NEDO-10958-A  
Class I  
January 1977

**GENERAL ELECTRIC BWR THERMAL ANALYSIS BASIS (GETAB):  
DATA, CORRELATION AND DESIGN APPLICATION**

The Regulatory staff has completed its review of the General Electric Company proprietary topical report NEDE-10958, "General Electric BWR Thermal Analysis Basis (GETAB): Data, Correlation and Design Application". Enclosure 1 is the Regulatory staff's evaluation of this report.

Figure 4 MEASURED VS. PREDICTED CRITICAL HEAT FLUX FOR ATLAS DATA WITH UNIFORM AXIAL AND UNIFORM

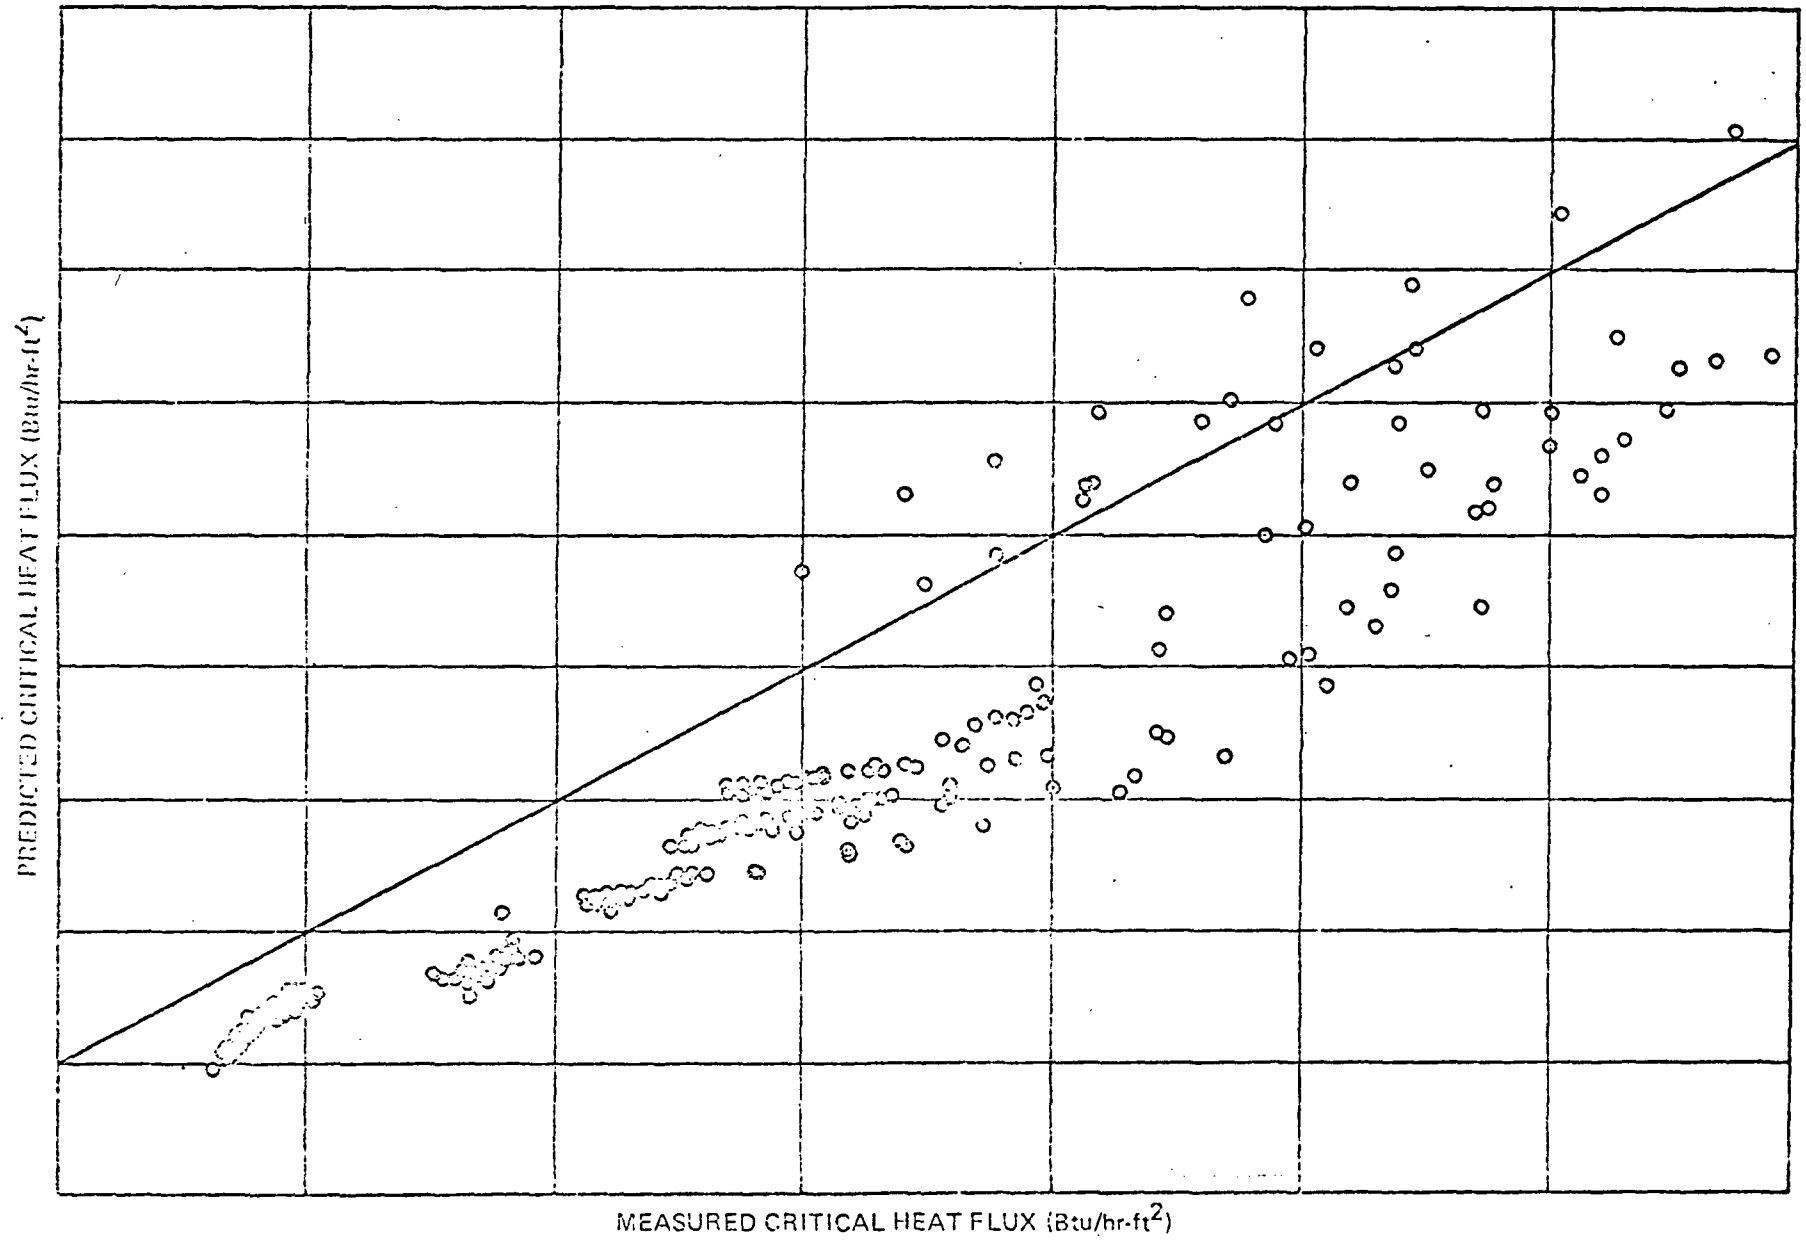
A comparison between measured and predicted critical heat flux (Hench-Levy) for uniform axial and radial heat flux distribution, is shown in Figure 4.<sup>(17)</sup> It can be seen that almost all of the measured heat fluxes are greater than the predictions thus showing that, for these conditions, the Hench-Levy correlation is conservative. This result is not too surprising as the experimental basis for establishing the Hench-Levy correlation was primarily comprised of uniform axial and radial heat flux rod bundle data. However, as shown in the following two figures, the greater the departure from uniform axial and radial heat flux distribution, the greater becomes the disparity between the Hench-Levy correlation and measured critical heat fluxes, with Hench-Levy being the higher.

Figure 5 MEASURED VS. PREDICTED CRITICAL HEAT FLUX FOR ATLAS DATA WITH UNIFORM AXIAL POWER PROFILE

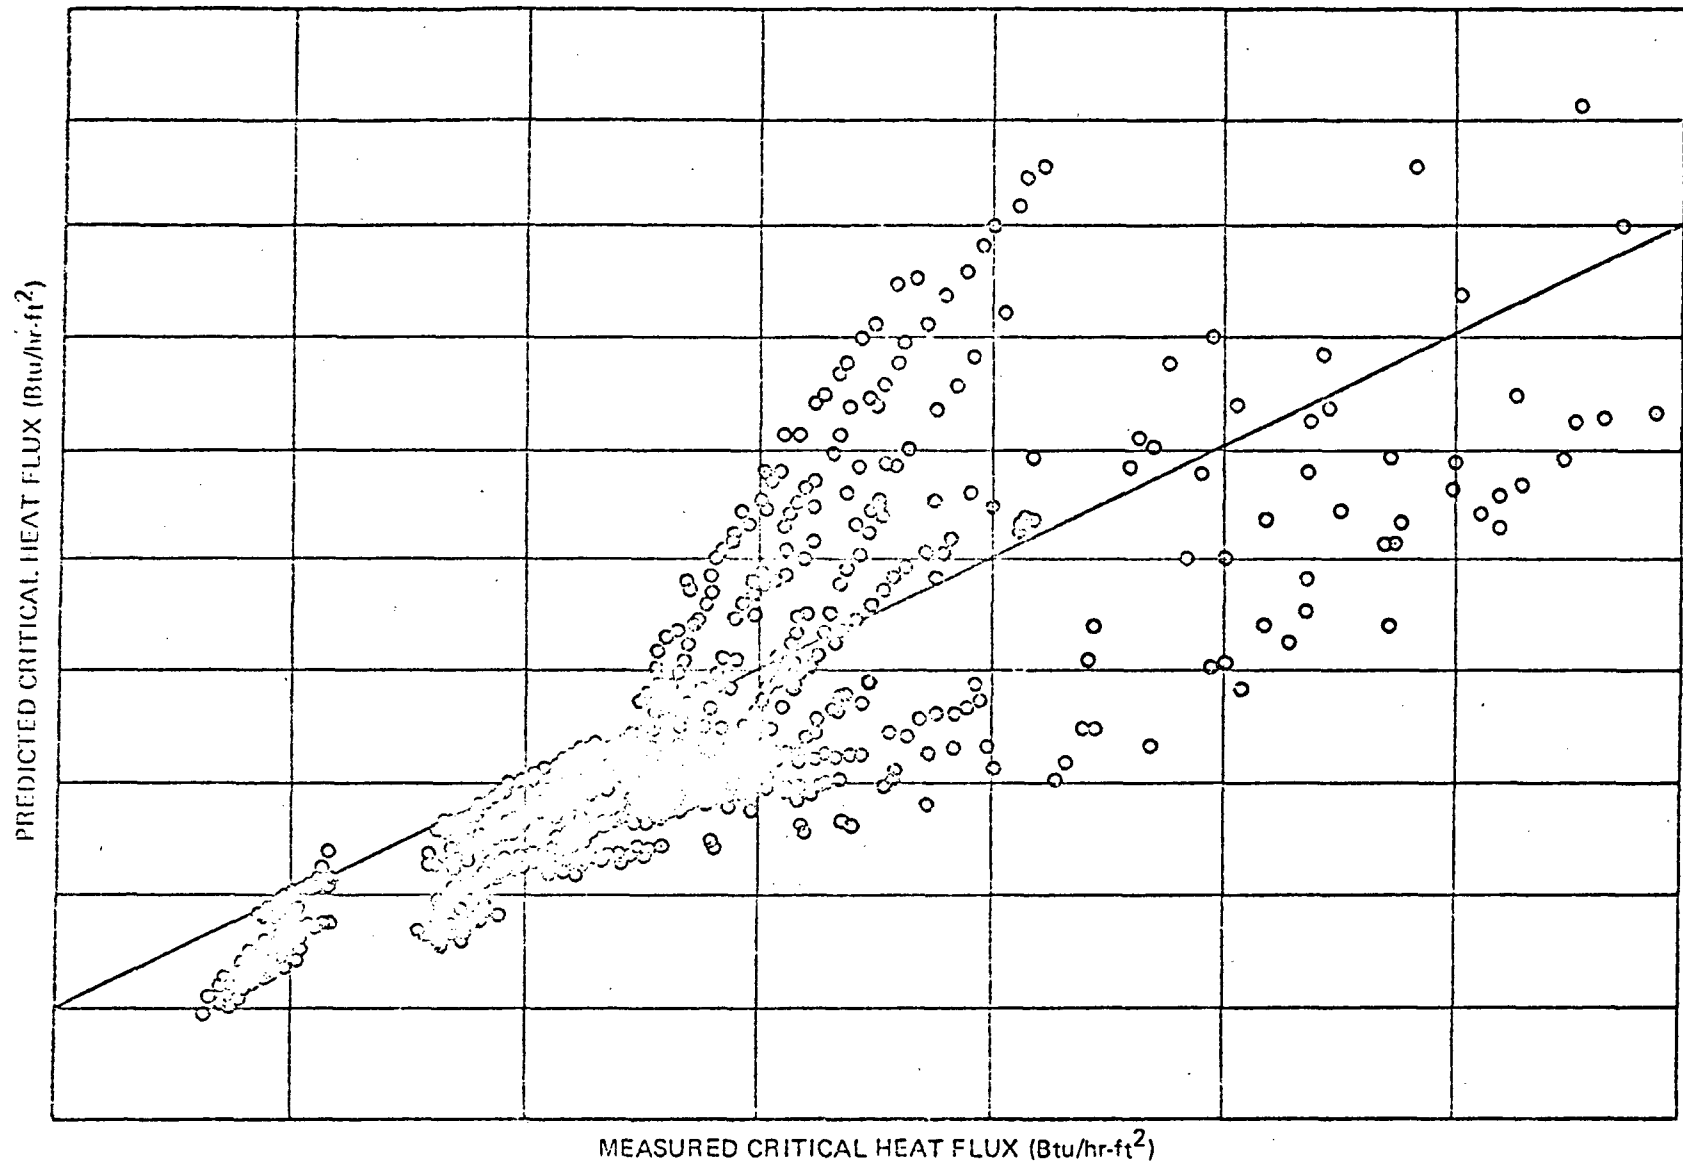
Figure 5,<sup>(17)</sup> which compares critical heat flux for uniform axial heat flux and non-uniform radial peaking to predictions, shows that about one-half of the data points are less than the Hench-Levy prediction. When corner peaking is combined with non-uniform axial heat flux distributions (cosine, inlet peak, outlet peak, double hump), the comparison in Figure 6<sup>(17)</sup> results. Here it is seen that, for the vast majority of data points, the Hench-Levy predictions substantially exceed the measured critical heat fluxes. Thus, it can be concluded that, for rod bundle heat flux distributions and heated lengths which correspond to those found in a GE BWR (non-uniform axial heat flux with corner peaking, 12 ft. heated length) the Hench-Levy correlation does not provide a lower limit line.

Figure 8 COMPARISON OF HENCH-LEVY AND GEXL WITH 49 ROD ATLAS DATA  
 (1.23 CORNER PEAKING, COSINE)

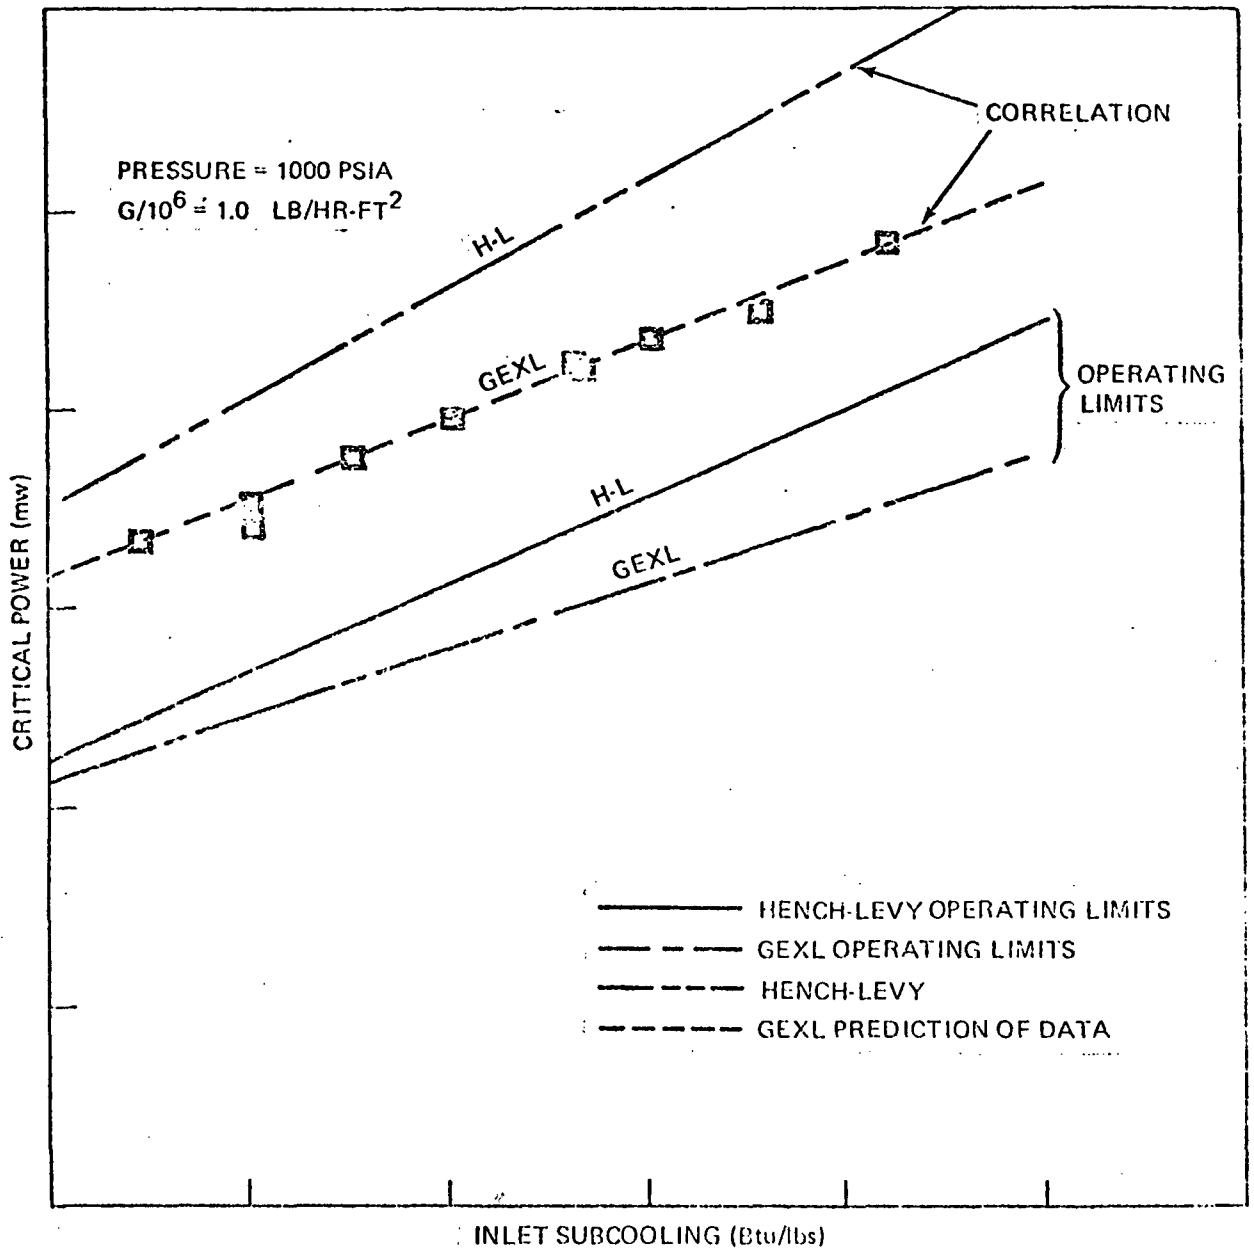
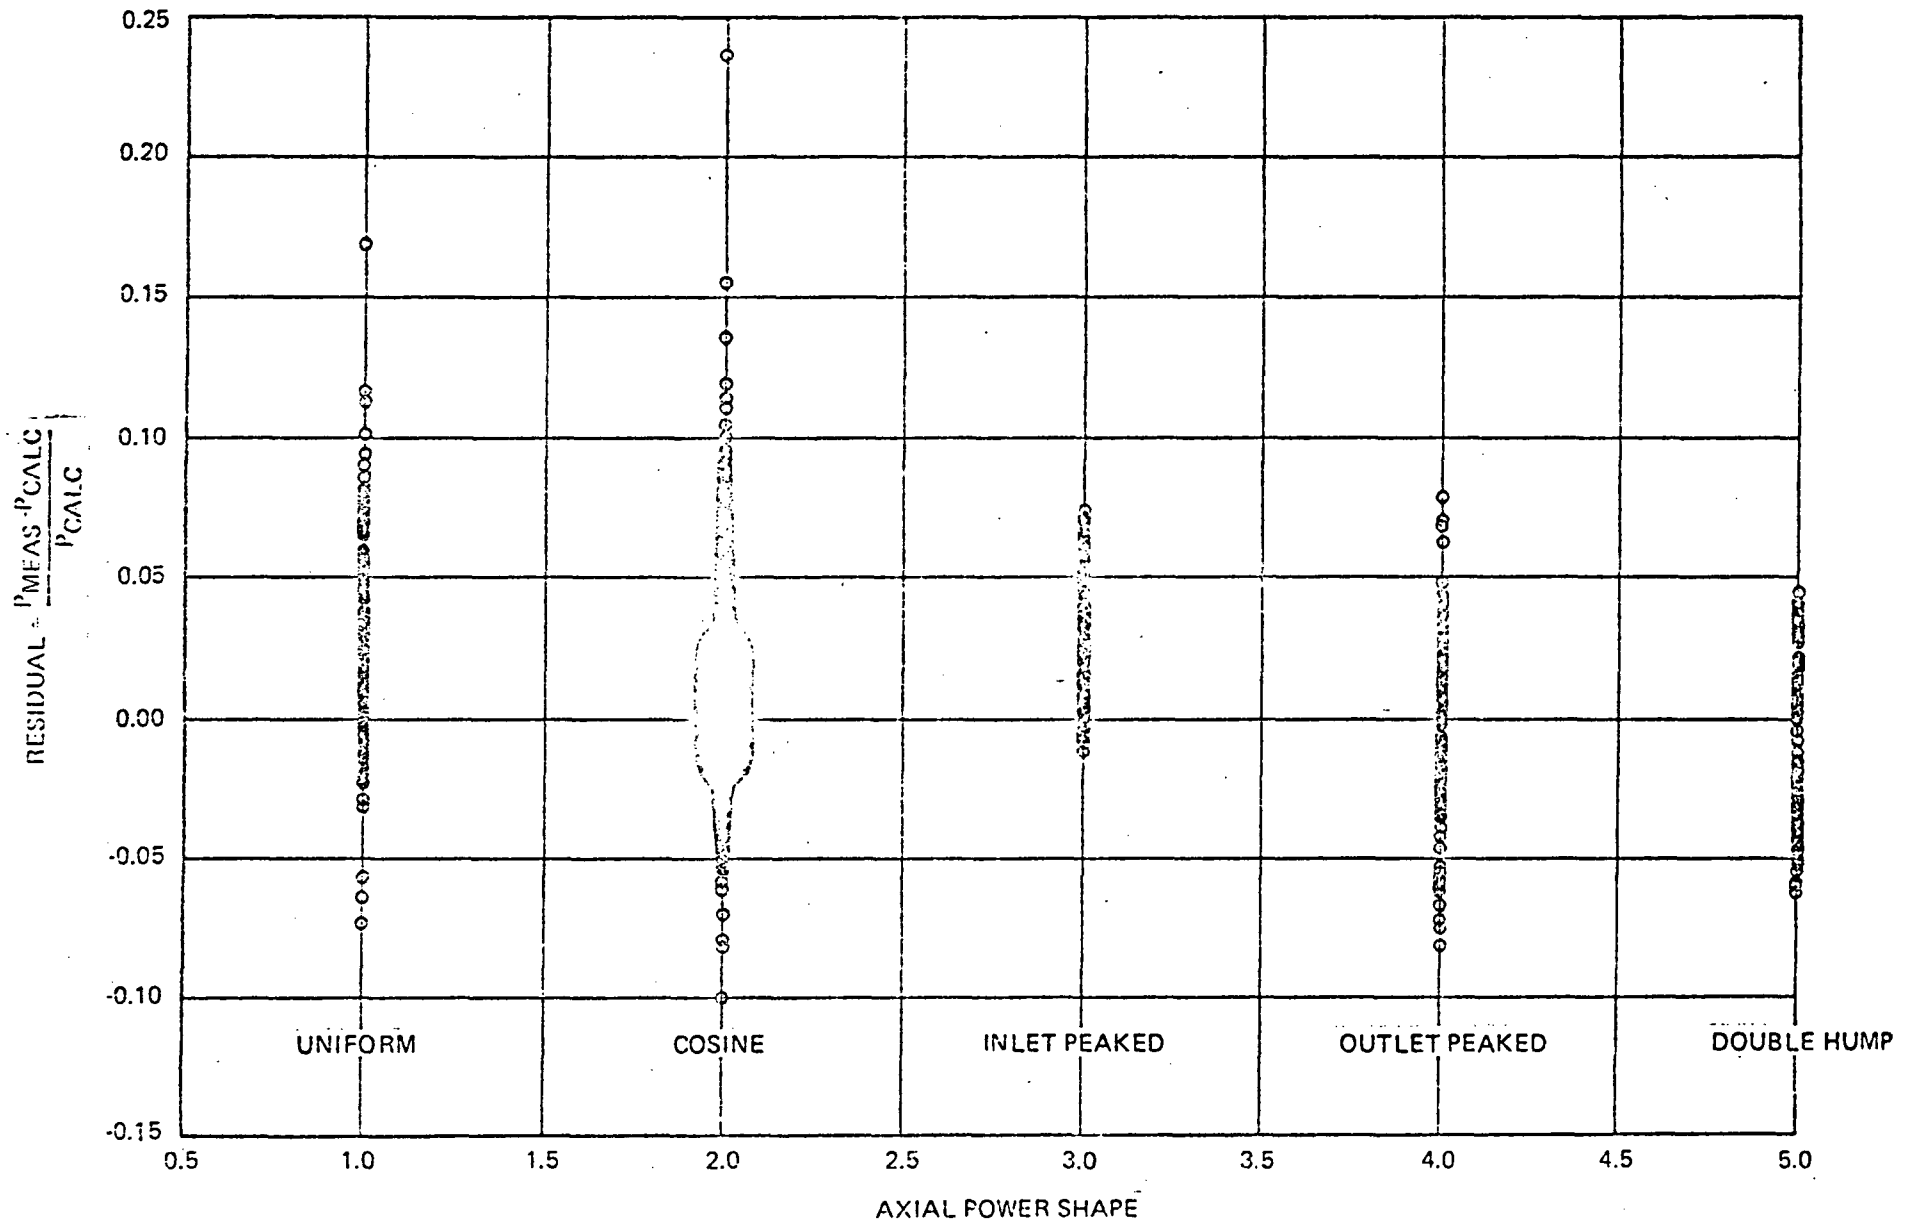
Figures 8 and 9 show critical power, for a 7 x 7 rod bundle, as a function of inlet subcooling, for mass velocities of  $.5 \times 10^6$  and  $1 \times 10^6$  lb/hr-sq.-ft., respectively. The two upper curves in Figure 8 represent the Hensch-Levy correlation and GEXL, respectively, along with experimental data. It is seen that the Hensch-Levy correlation predicts about 5 percent greater power than GEXL or the data. The two lower curves represent the operating curves for each of the correlations; Hensch-Levy is based on critical heat flux divided by 1.9 whereas GEXL is, in a typical case, based on critical bundle power divided by 1.2.\* Note that, with respect to the operating curves, GEXL permits higher power than Hensch-Levy at low inlet subcoolings while the converse holds true at high inlet subcoolings. At a mass velocity of  $1 \times 10^6$  lb/hr sq. ft., as shown in Figure 9, both the Hensch-Levy correlation and its operating curve are always higher than the respective GEXL curves.

\*As discussed in Section 4, use of the arithmetic mean, rather than the geometric mean, in the statistical analysis, will increase the required CPR from 1.20 to 1.24. This would correspondingly lower the GEXL operating curves on both Figure 8 and 9.

The variation of the ratio of the difference between the measured and calculated power to calculated power with axial flux shape is shown in Figure 10. When compared to the uniform and cosine power shapes which formed the basis for the 7 x 7 and 8 x 8 GEXL correlations, the inlet peak shape is seen to be slightly conservative while the outlet peak and double hump shapes are slightly non-conservative. The same relative positions among the various axial power shapes is shown, in terms of predicted to measured power, on p. 5-5 of Reference 3. However, it should be noted that these comparisons are applicable only to the 7 x 7 lattice as data with inlet peak, outlet peak, and double hump axial shapes have not, as yet, been obtained with the 8 x 8 lattice.
